Re: Cisco FCC ID LDK-OFDM-MMDS2
Your email: 11 August 1999

Correspondence No: 9181
Confirmation No.: EA94329

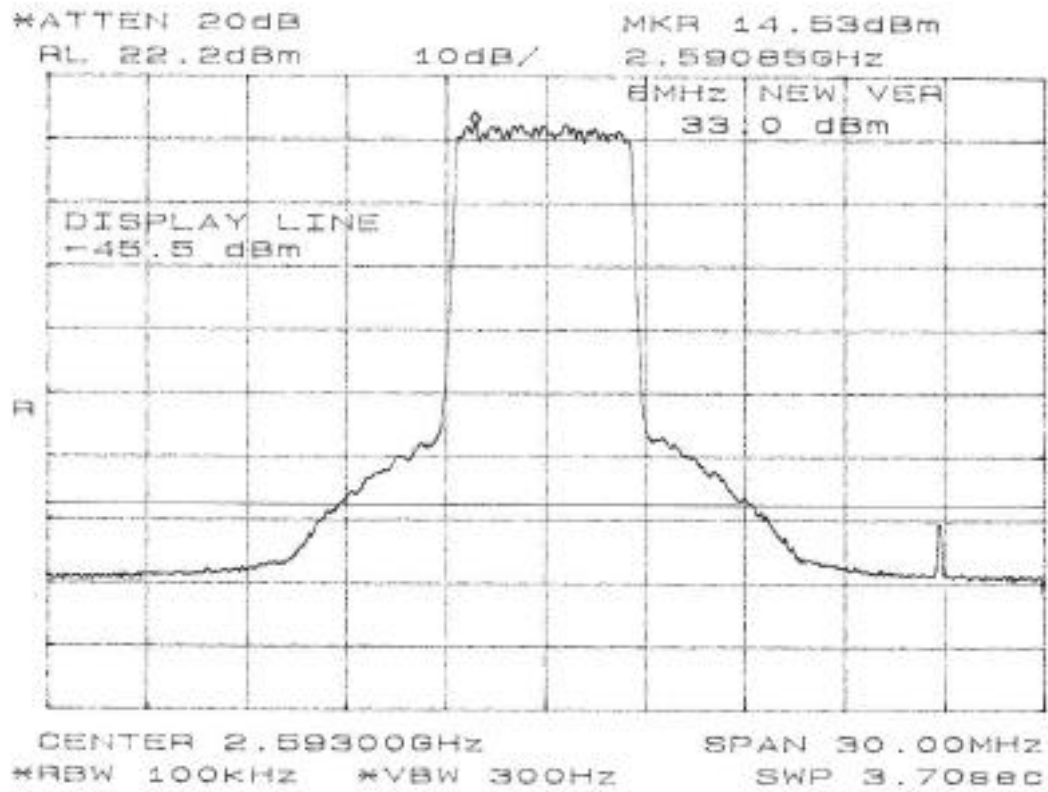
5. □ Refer to page 27 of the test report, with spectrum analyzer chart titled, "Antenna Conducted Emissions, 6 MHz Channel Bandwidth (1 of 7)". The -60 dBc level is -44.4 dBm, shown by the display line. The relationship of field strength and power input to a dummy load

The HP84125C, when used with the memory card supplied with it, applies all corrections such as cable loss, antenna factor, and amplifier gains to the received signal and displays a corrected field strength level on the spectrum analyzer screen. System operation is verified per user manual by connecting a signal generator to where the antenna port would normally connect, and comparing the displayed emission level with the theoretical level calculated for the system loss/gain parameters.

When checked in this manner, the HP84125C system readings were within +/- 2 dB of calculated values.

The display line of the HP84125C was set to 60.4 dBuV/m, the level calculated as being the field produced by a -44 dBm signal into a dummy load/transmitter case located 1 meter away. The corrected data on the spectrum analyzer plot is below the 60.4 dBuV/m limit line for emissions up to 10fo.

TX Output, 6 MHz channel, w/ Fujitsu RF Power Transistors

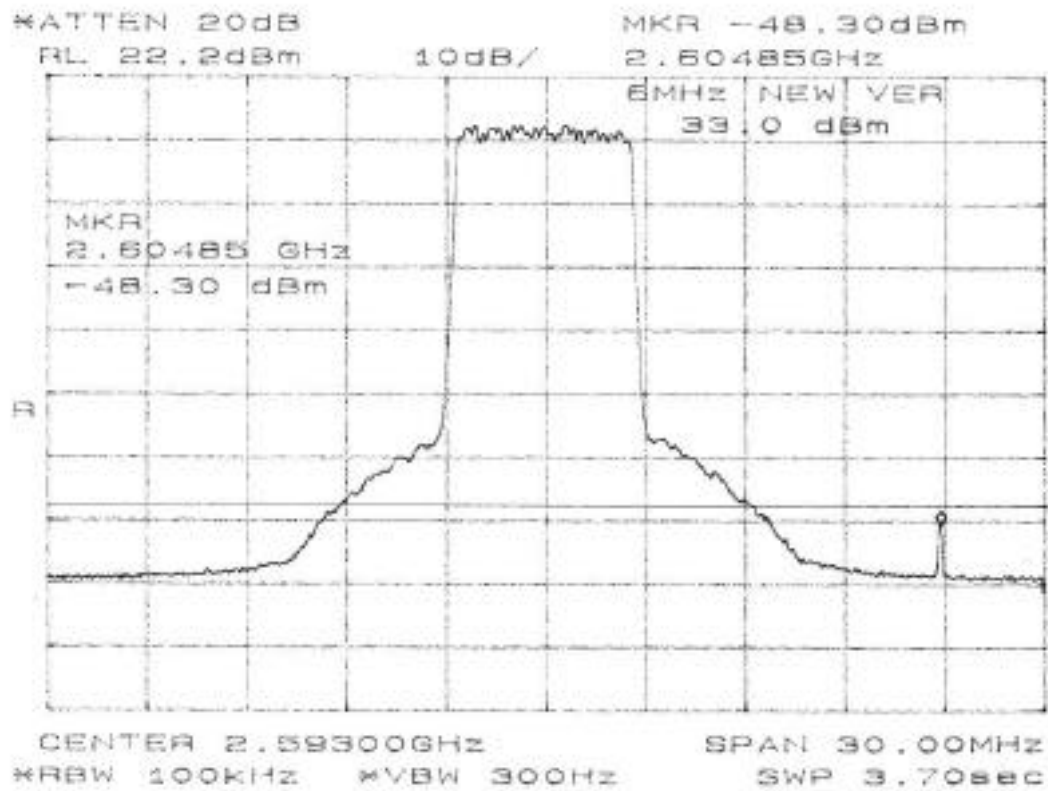
In addition, a new issue. There was a change to the transmitter RF power amplifier circuit - in the time that elapsed after the application was filed, Cisco found it necessary to change vendors for the GaAsFET RF amplifiers. The transistors are now being supplied by Fujitsu. In addition to this change, minor board layout errors and omissions were corrected since the filing in May for FCC certification. New schematics, PDF files named "Blaze2", have been uploaded to the FCC electronic filing site already.

As a result of these changes, output power has been increased: 6 MHz channel.....33 dBm
12 MHz channel.....31.5 dBm

Out of band spurious and harmonic emission suppression is equal to or better than that already reported. New spectrum analyzer charts are attached below, showing compliance with -60 dB suppression requirement. Note that measurements for broadband signals are referenced to emission flat top, but the CW spurs are referenced to the 31.5 dBm or 33 dBm total average channel power, as amplitude of CW is independent of resolution bandwidth.
